Re Input on Proposed Harmonisation Docs – 23rd PPIHWG Montreal

Ref. 991116/16 - 25.903(e) Inflight Starting
Attachment 11

Engine Inflight Restart Requirements

Subject: P&W Comments on Proposed §25.903(e)

CHART 2
Commercial Transport Fleet All-Engine Power Loss Events, by Flight Phase
1960-1996

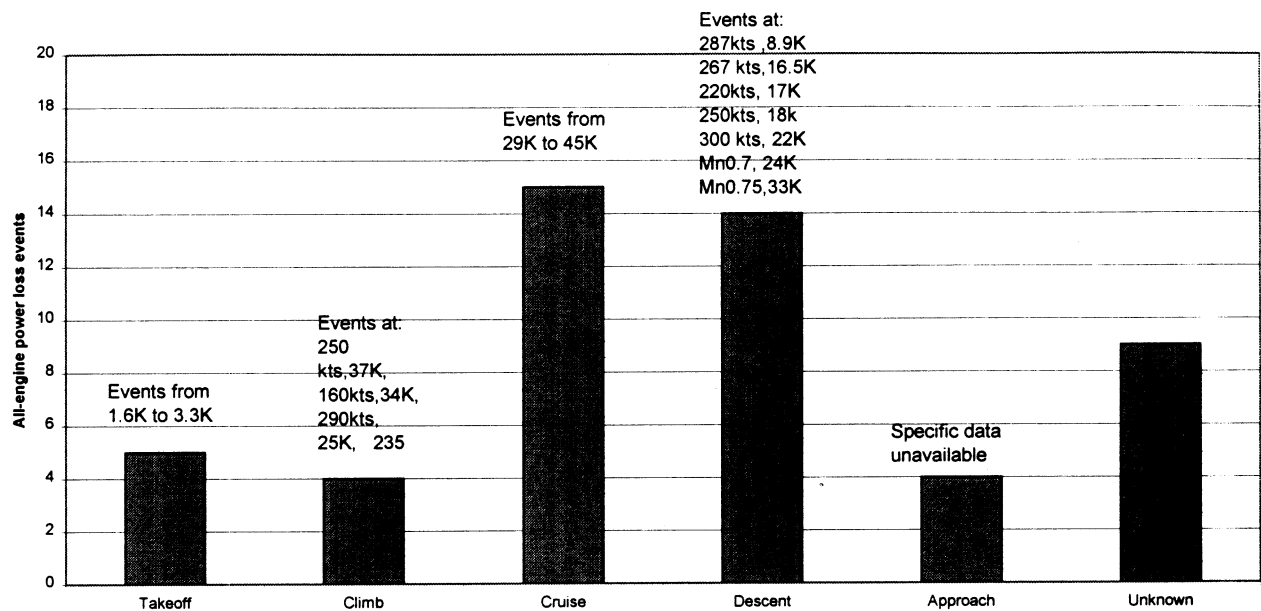
**Majority of events occur at high/intermediate altitudes.
Low altitude/low airspeed/low power scenario (condition 4)
represents no events/ a very small proportion of events**

Chart 3
Certified Windmill Start Envelopes

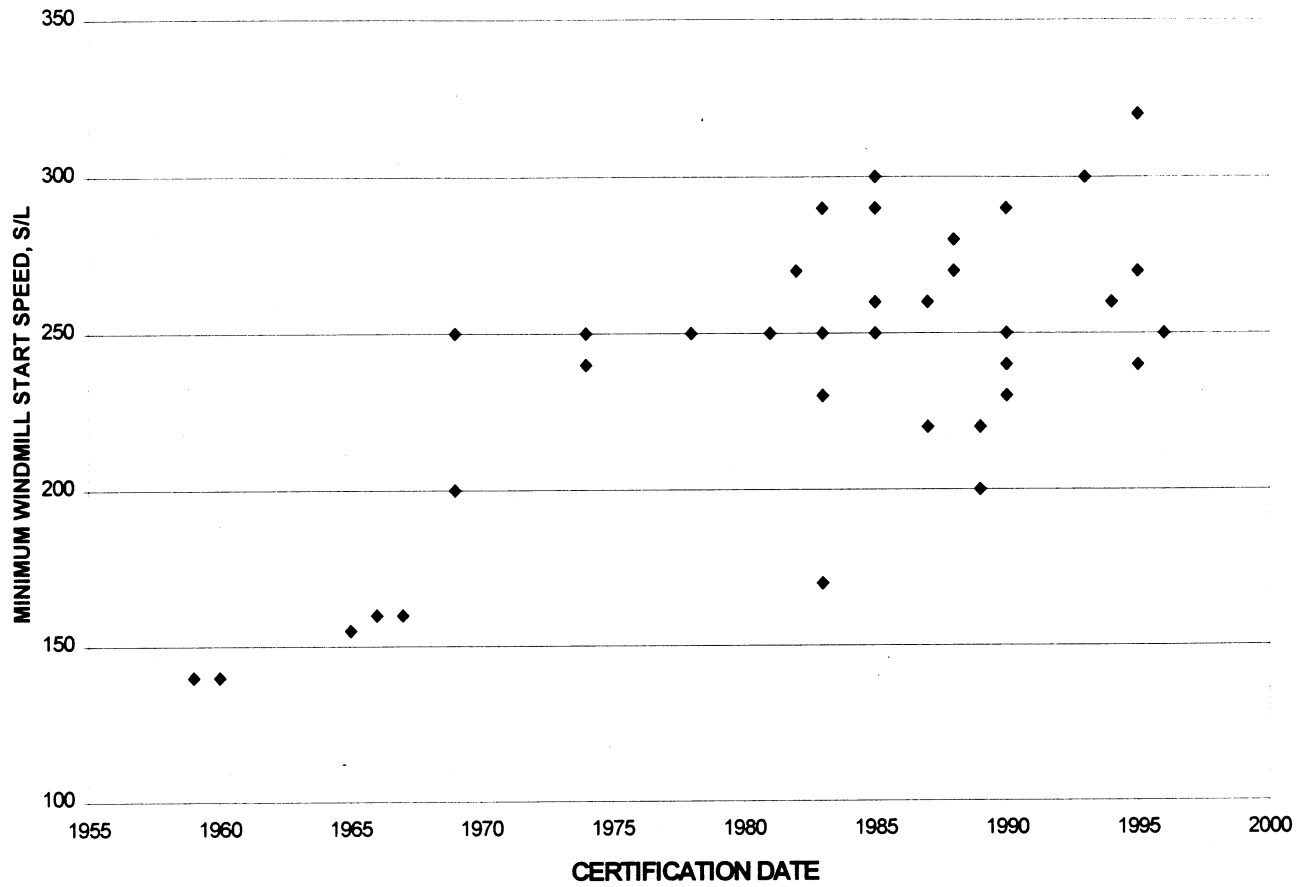
Chart 3 shows the minimum windmill start airspeed as a function of aircraft certification date. Half of the engine/airframe combinations currently in service are capable of windmill start, S/L, at 250 knots. Therefore a reasonable criterion for maintaining the current safety standard would be 250 knots rather than 1.45 V_{stall}. The following wording change is proposed to Section 7, condition 4:

The initial airplane speed that should be used for the all-engine out restart evaluation is **250 kts**. Acceptable means of compliance include rapid relight, starter assistance from an external source and stabilized windmill start. The airplane should not lose more than 5000 feet altitude between initiating restart procedures and achieving level flight.
